Raytheon Aircraft

MANDATORY SERVICE BULLETIN

No. 2242, Rev. I
ATA Code 27-30
Recurring Inspection

SUBJECT: FLIGHT CONTROLS - INSPECTION AND/OR REPLACEMENT OF MAGNESIUM ELEVATOR CONTROL FITTINGS

Figure 1

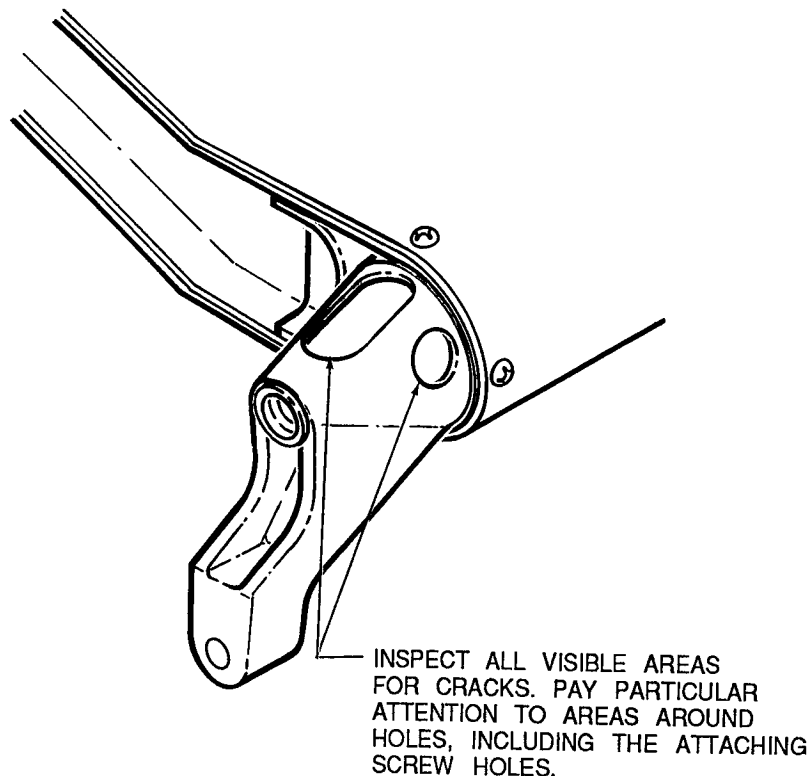
1. Refer to Figure 1 and inspect both elevator control fittings as shown.

2. Ensure correct freedom of movement of both elevator control fittings.

Figure 2

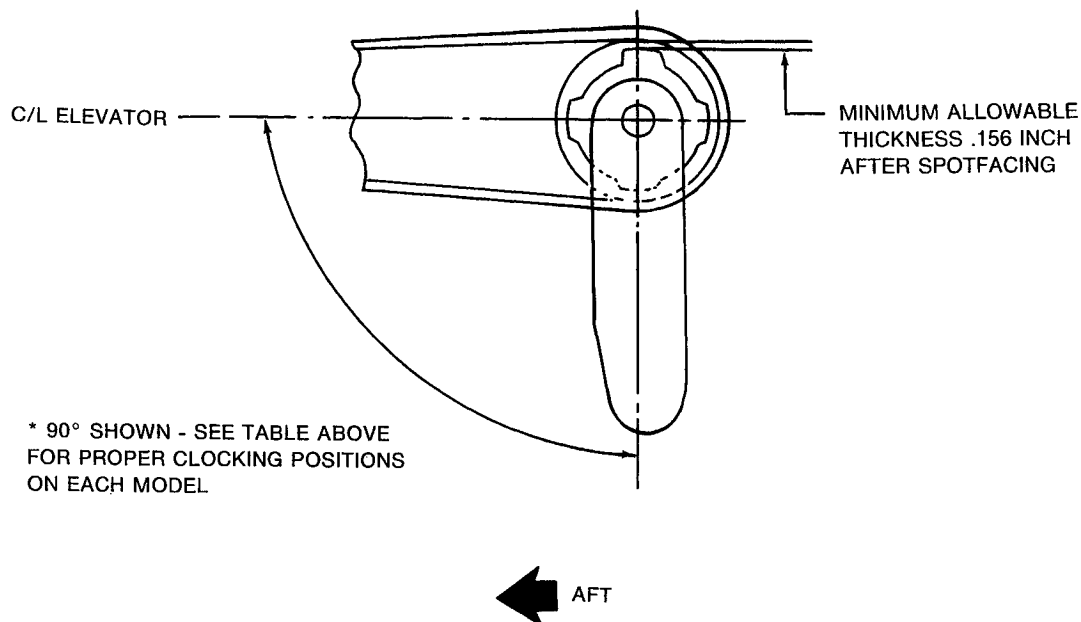
1. If a new fitting is required:
 - a. Remove the elevator from the airplane and remove the existing fitting from the elevator.
 - b. Install a new elevator control fitting on the elevator in the correct position. Refer to Figure 2 for correct position.
 - c. Mark one hole on the new fitting, using an existing hole in the elevator as a template.

g. Back spot face the four holes (on the inside of the fitting) until a flat surface is obtained. The minimum allowable thickness of the spotfaced area is .156 inch. Refer to Figure 2.

i. Use new hardware for the new fitting installation. See Figure 2.

NEW FITTING INSTALLATION:

DRILL 4 .190/ .194 INCH DIAMETER HOLES

BACK SPOTFACE 9/16 WITH .06 INCH CORNER RADIUS (EXCEPT
V-TAIL BONANZAS AND T34A & T34B AIRPLANES)
MINIMUM ALLOWABLE THICKNESS, .156 INCH AFTER SPOTFACING
AN23-9A /M/ BOLT (4 PLACES) (ALL AIRPLANES EXCEPT
V-TAIL BONANZAS AND T34A & T34B AIRPLANES)

AN23-10A /M/ BOLT (4 PLACES) (V-TAIL BONANZA AND T34A
& T34B AIRPLANES ONLY)

AN960-10 WASHER (4 PLACES)
130909N29 NUTS (4 PLACES)

USE NEW HARDWARE FOR REINSTALLATION OF FITTING
